RE: CPA2022-00014 and CPA2022-00015

The Preserve Sporting Club and Residence Map and Text Amendments

Staff has reviewed the materials submitted for Lee Plan map and text amendments, CPA2022-00014 and CPA2022-00015, received on May 12, 2023. Staff finds that the application materials are insufficient and further information is needed.

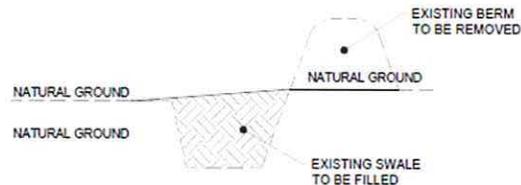
4. Please provide the results of the 25 year 3 day storm simulation, similar to Figure 33 (100 year design storm event).
5. Please explain how the flow and operation parameters shown in the image below were decided. These two surface water pumps do not match the flow capacity or operation parameters described in the response to insufficiency comment 6(g) within the Sufficiency Response Letter dated 5/11/2023.
